Intel Bay Trail-M Platform Block Diagram

Quanta Computer Inc.
PROJECT : NL6

DOC NO.	PROJECT MODEL : Chrome	APPROVED BY:	DATE:	 Quanta Computer Inc. PROJECT : RL6 Change list
	PART NUMBER:	DRAWING BY:	REVISION:

Model Version CHANGE LIST

Size	Document Number	Rev
	Valley 5/9 (SPI/GPIO/CLK)	1A

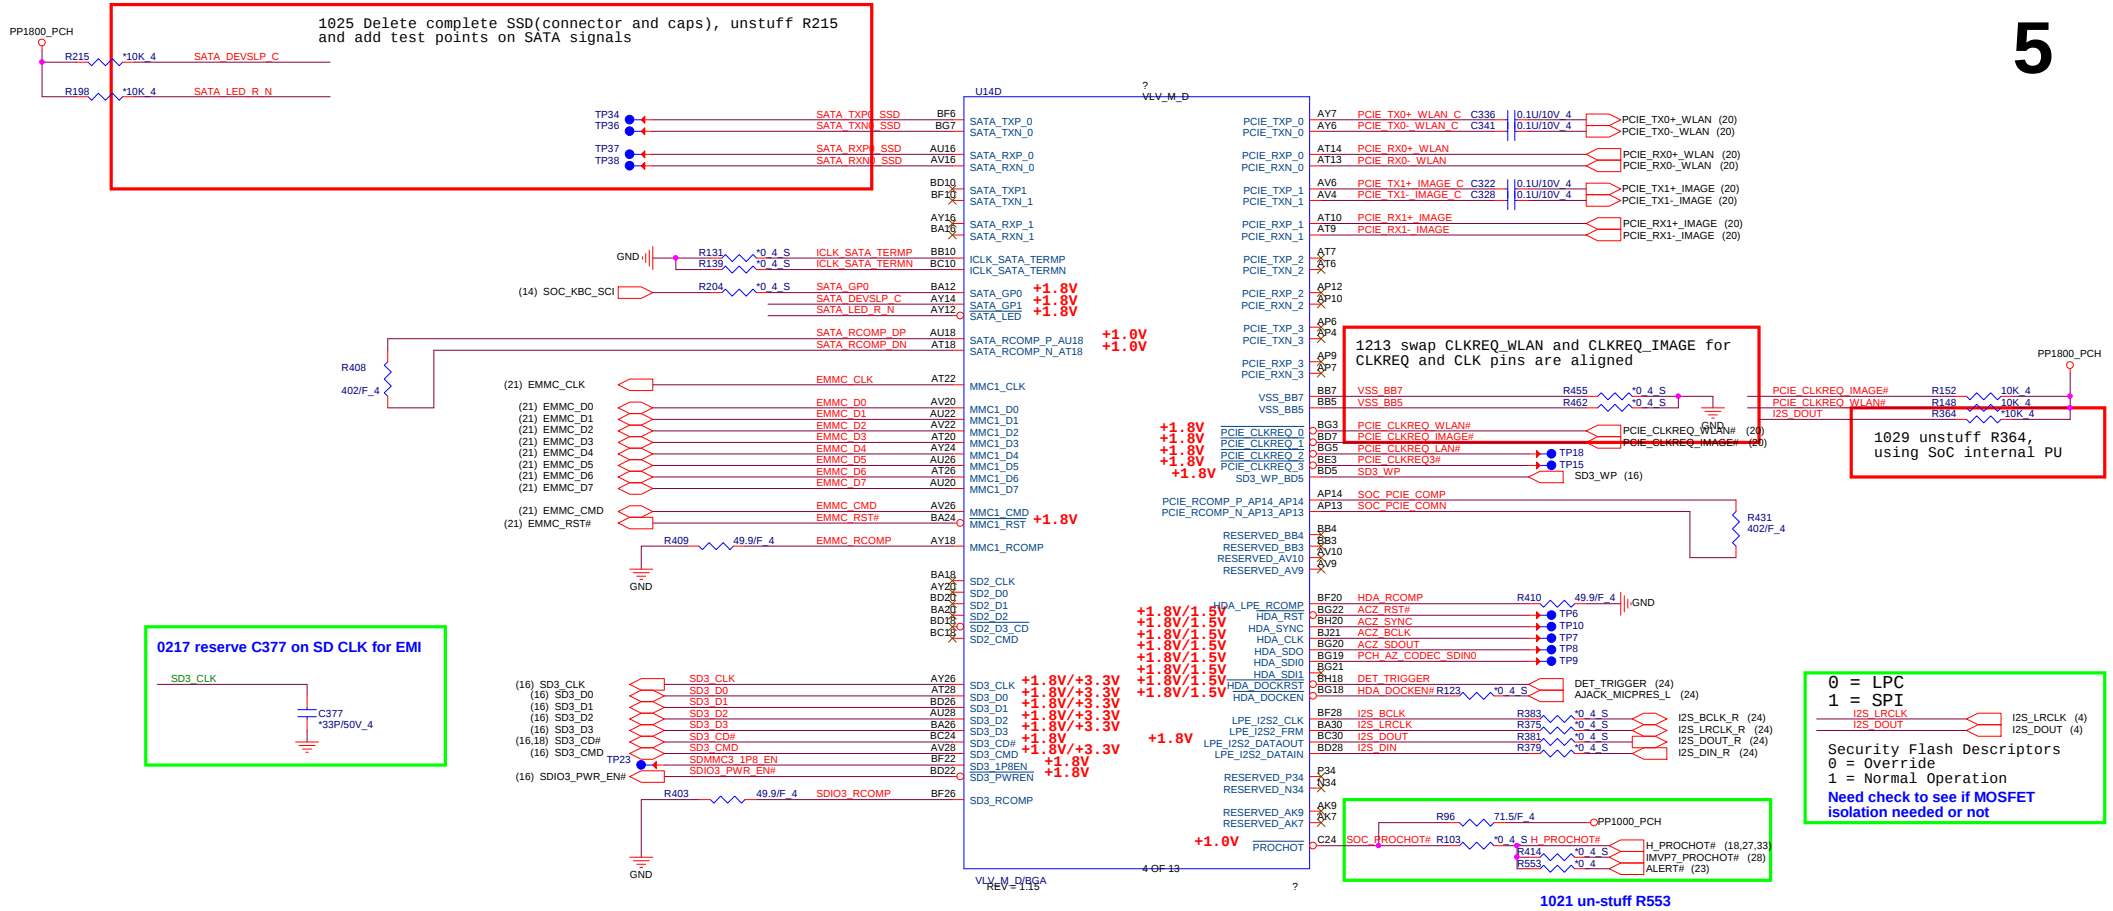
1029 unstuff R386, using SoC internal PU	
1115 stuff R386, it is required for eDP

1031 remove R417, PRDY should
be direct connection between
SoC and XDP by intel request

9/6 Add EC_RCIN_L for warm boot,
EC side is OD type

Size	Document Number	Rev
	Valley 7/9 (Power 1)	1A
Date:	Friday, April 25, 2014	Sheet 8 of 41

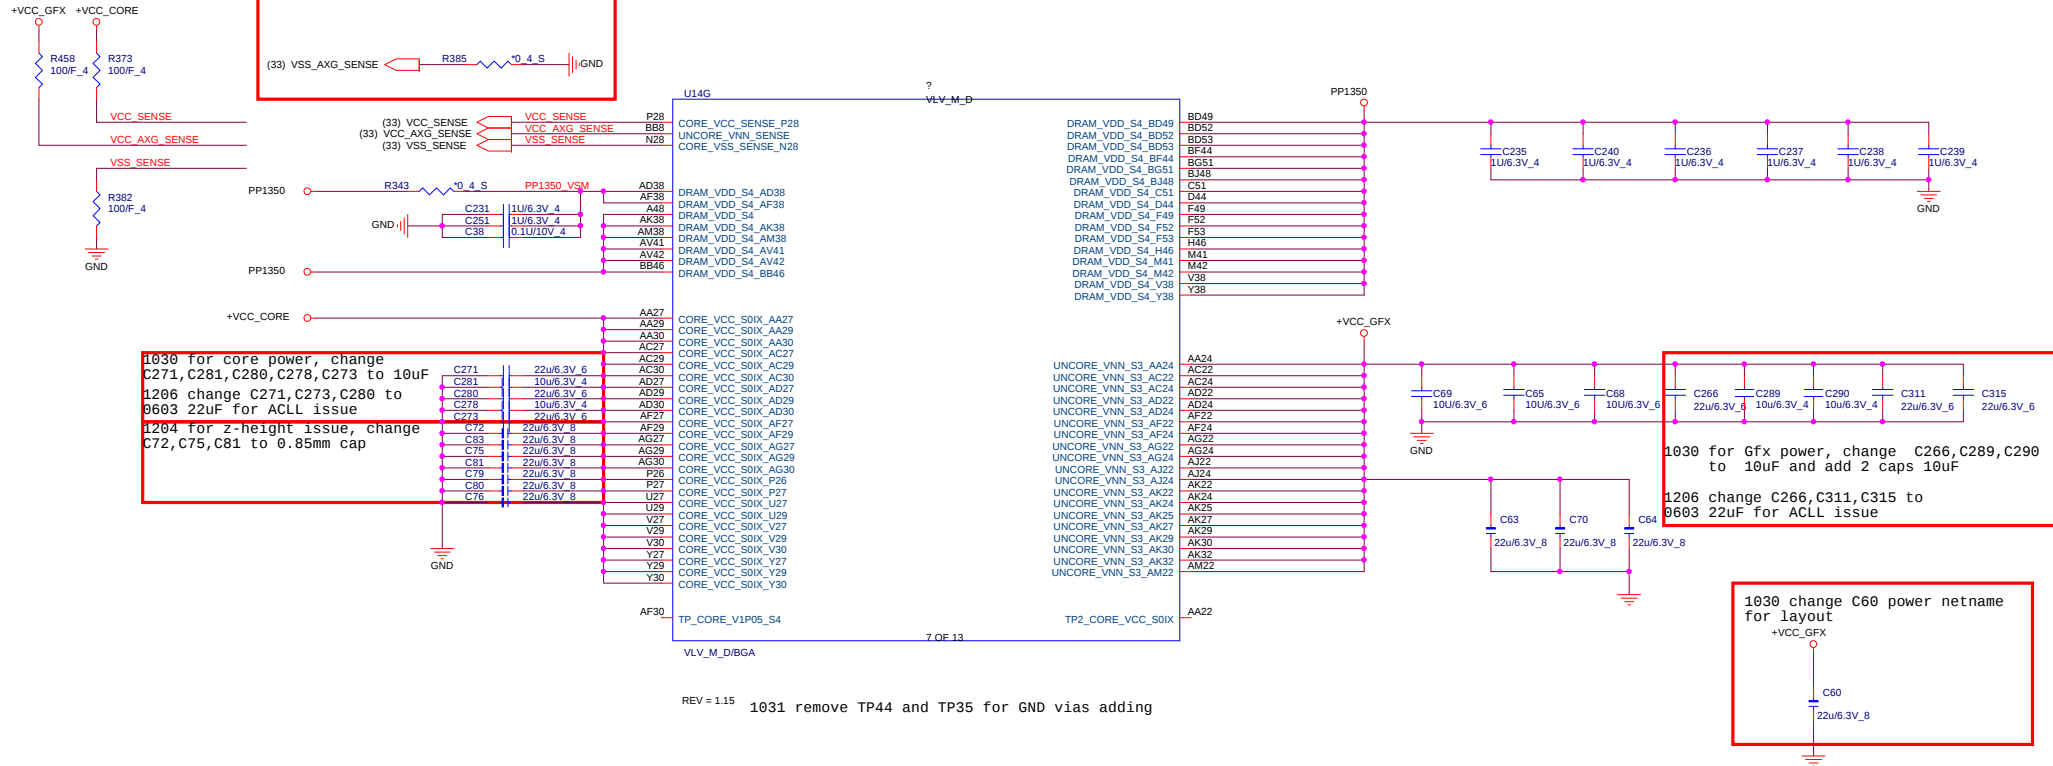
1031 for layout suggestion by intel, VSS_AXG_SENSE didn't connect to VSS_SENSE, will connect the GND via near VCC_AXG_SENSE
1031 for layout, add 0hm between GND and VSS_AXG_SENSE

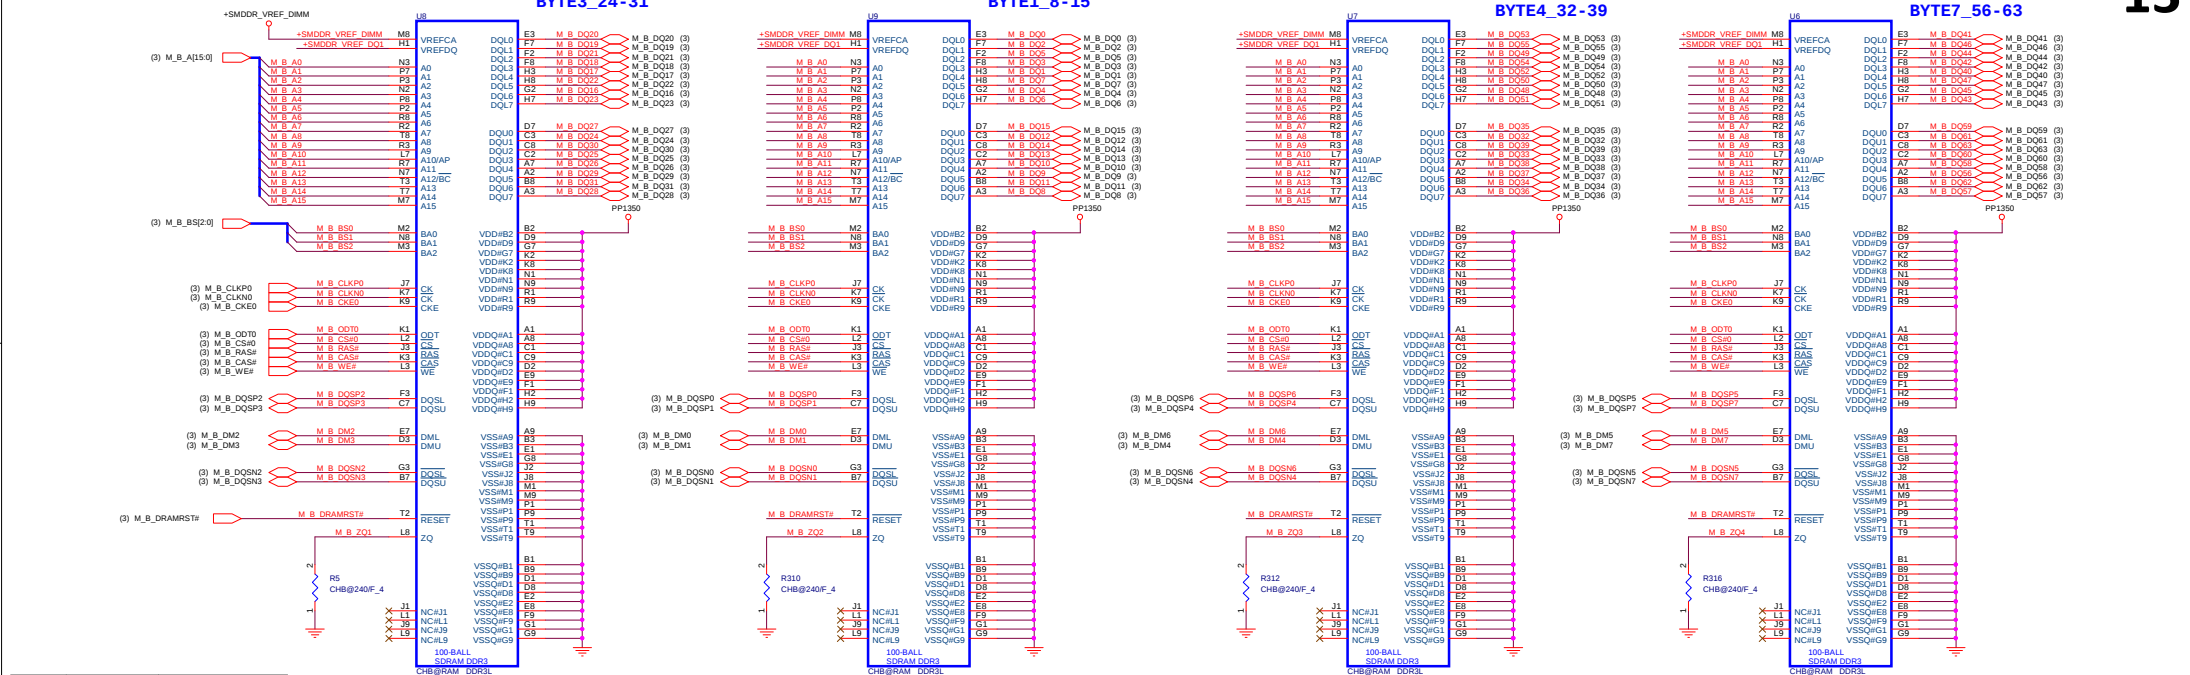
1024 change ODT PU to VTT
by Intel request

PWRON SEQUENCE

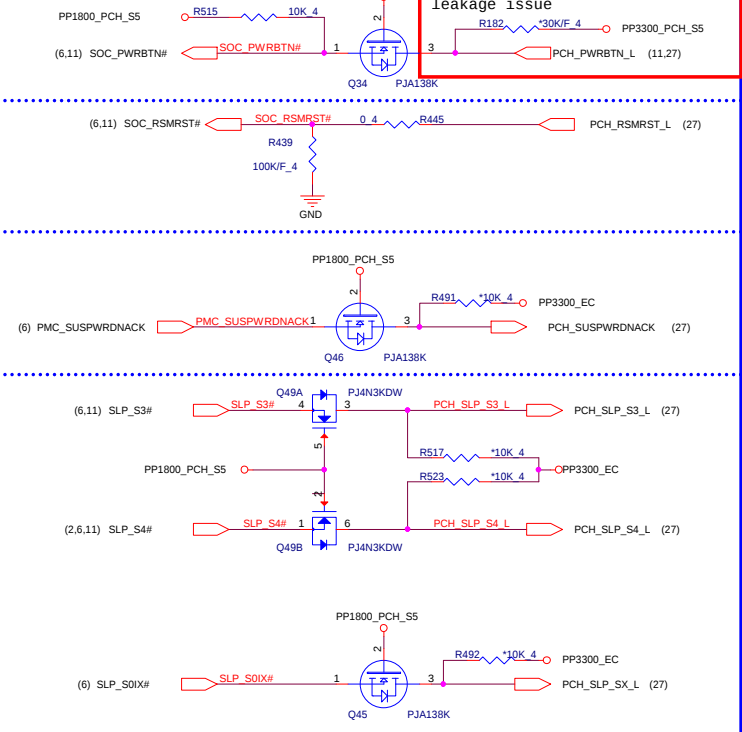
0128 change power rail of Q35,Q36,Q37,Q44 from PP1800_PCH_S5 to PP1800_PCH for PP1800_PCH leakage issue in S3 mode

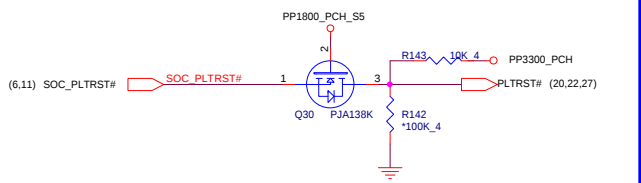
0206 remove/delete SPI_SIO Interface, Q35,Q36,Q37,Q44,R486,R484,R485,R483,R426,R429,R427,R428

Size Document Number Rev 1A
 SDIO CardReader
 Date: Friday, April 25, 2014 Sheet 16 of 41

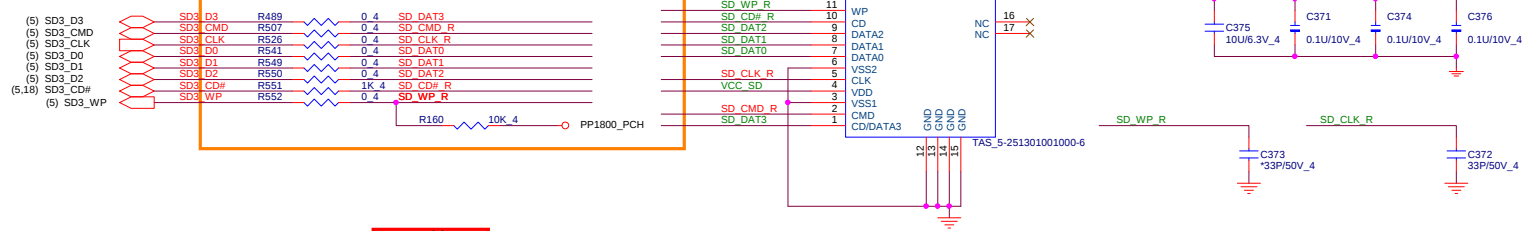
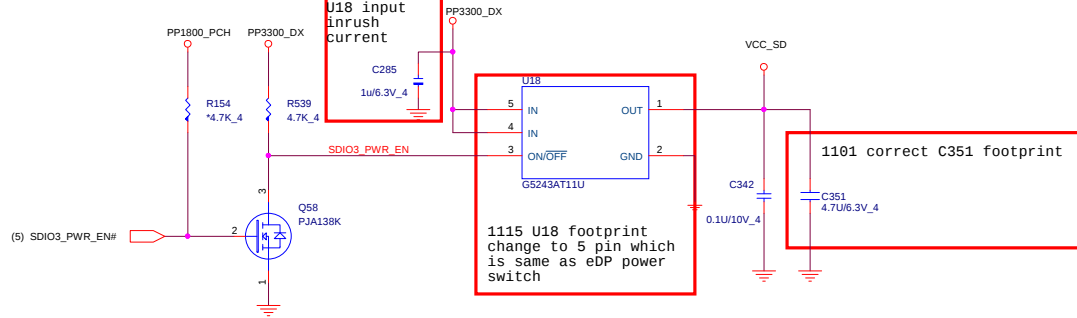
1205 the damping of SDIO change to 0 ohm by Intel request
 1205 add PU for SDIO WP by Intel request
 1205 R551 changes to 1K to isolate SD socket and servo/SoC
 1205 SD3_WP is 1.8V power rail in SoC, change external Pulled up power well of SD3_WP to 1.8V power

1202 add C285 for U18 input inrush current

1211 add pulled up resistors on SDIO data/cmd lines
 1212 all pulled up resistors of SDIO data/cmd to be un-stuffed

Size	Document Number	Rev
	Google Debug	1A
Date:	Friday, April 25, 2014	Sheet 18 of 41

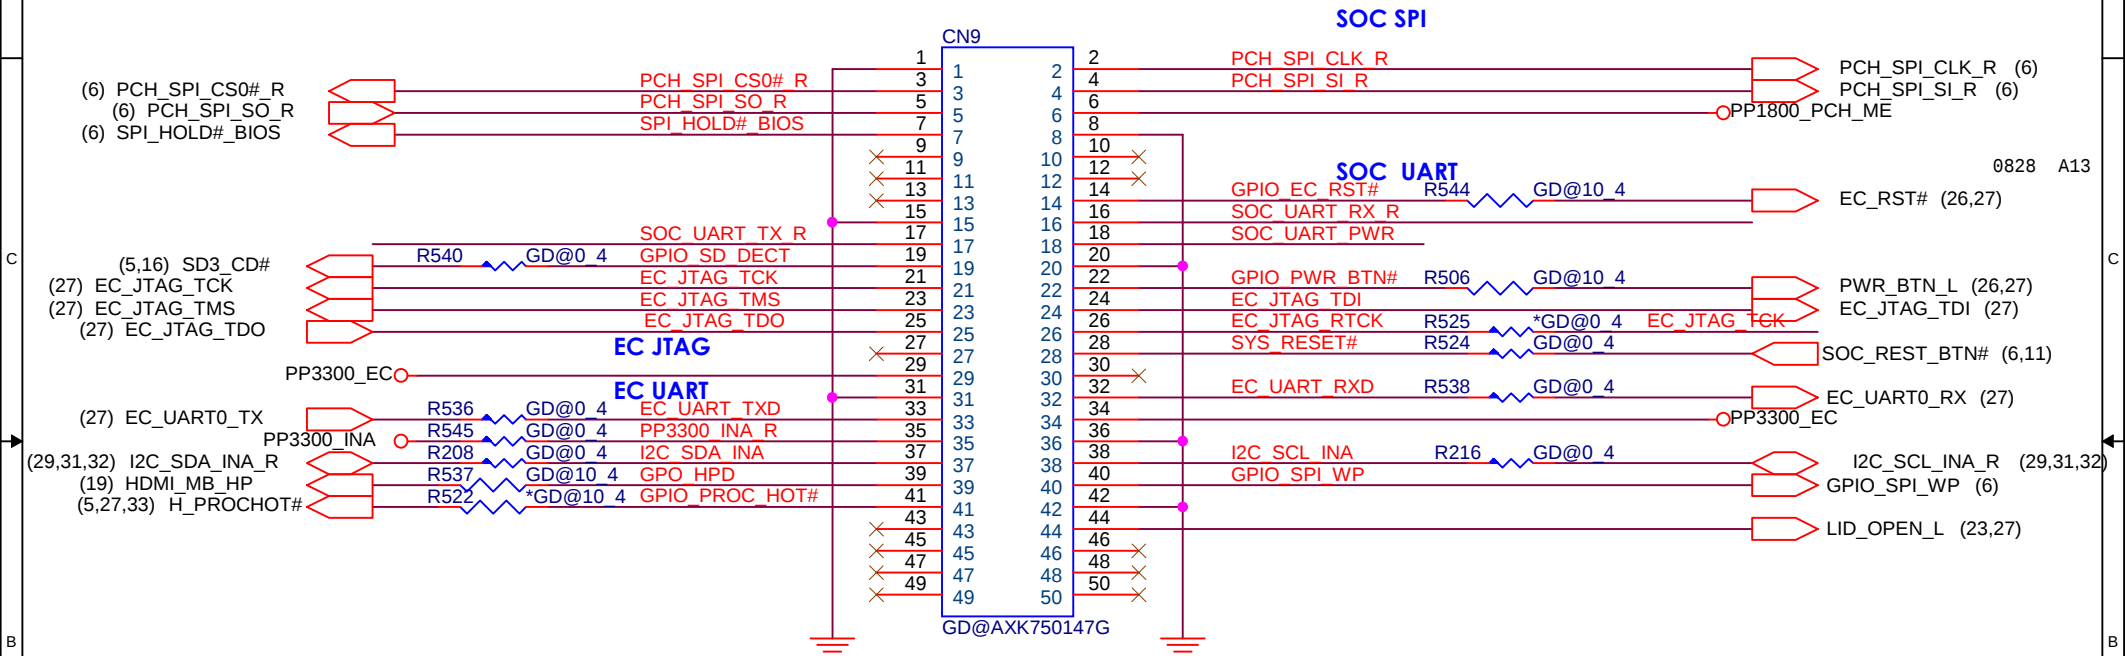
1021 change footprint and PN

9/13 add pull up

9/6 using optional instead of level shifted, default is from SoC

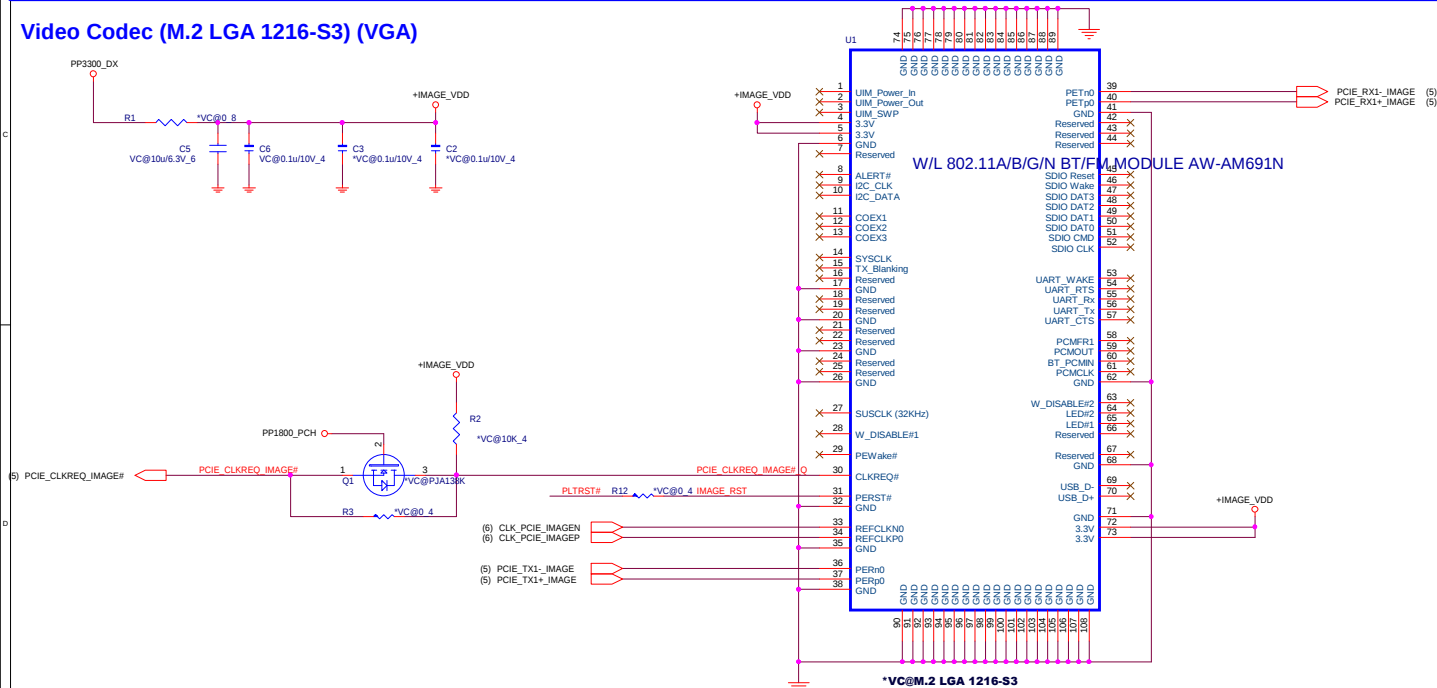
1025 Delete complete SSD(connector and caps)

HEADPHONE/Mic combo(ADO)

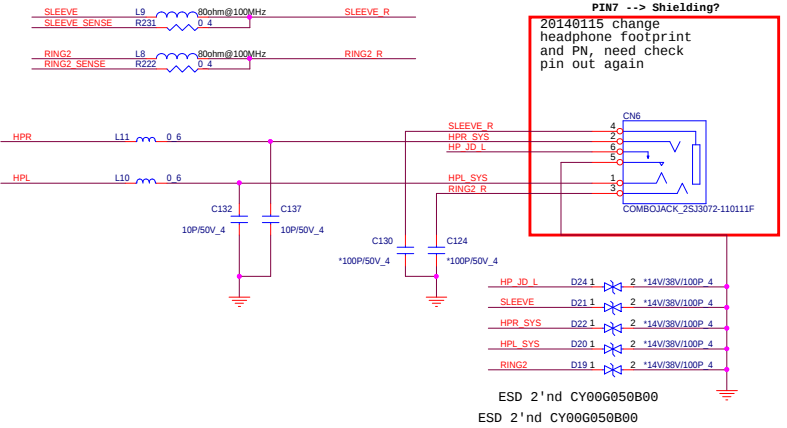
20140115 change
headphone footprint
and PH, need check
pin out again

Size Document Number KBC TI TM4E1G31H6ZRB1
Date: Friday, April 25, 2014 Sheet 27 of 41

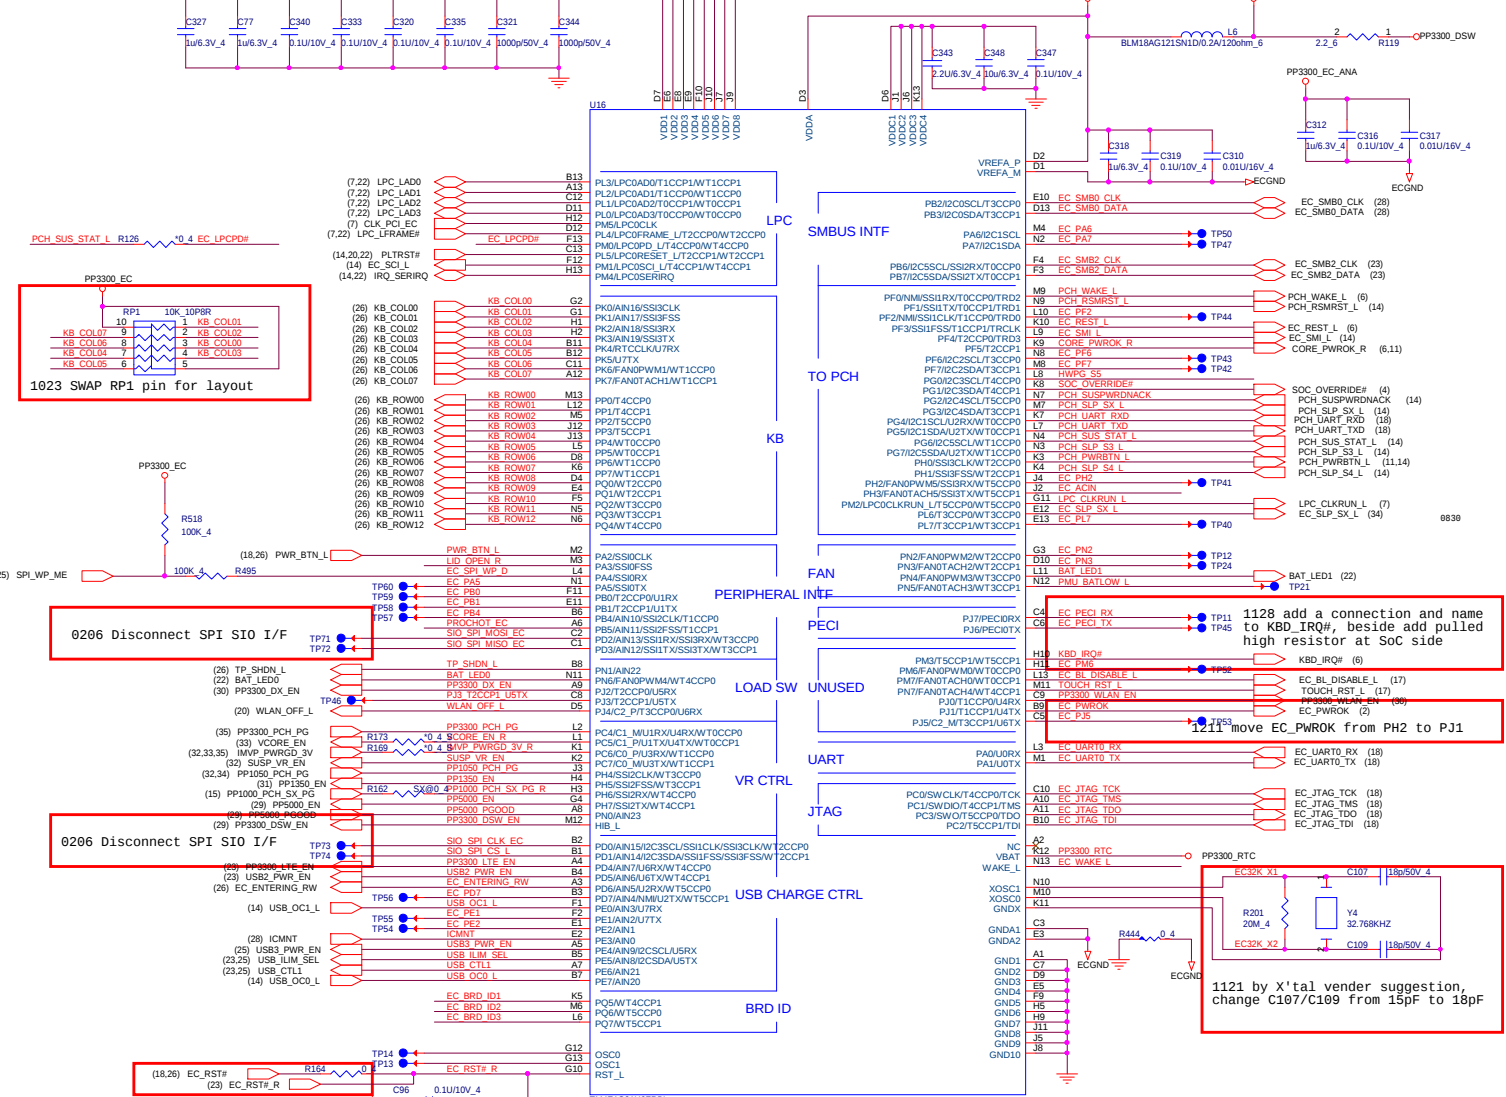
1212 change part number of EC ,which has a trial firmware inside

1211 add Test points on unused pins, need check layout to see if all points are ok

1213 Board ID of proto2 change to 001

1212 add connection and name to KBD_IRQ#, beside add pulled high resistor at SoC side

1211 move EC_PwROK from PH2 to P31

1211 by X'tal vender suggestion, change C107/C109 from 15pF to 18pF

1030 Thermal IC VDD has two option, one is PP3300_DSW(=PP3300_EC), another is PP3300_DX, default is stuffing to DSW rail

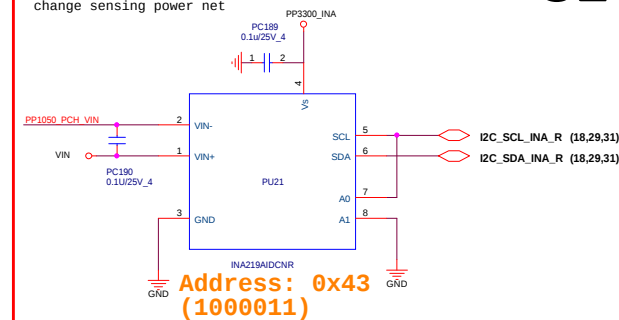
1129 because of power source of PU24, PU25 chagen to VIN, so that need change sensing power net
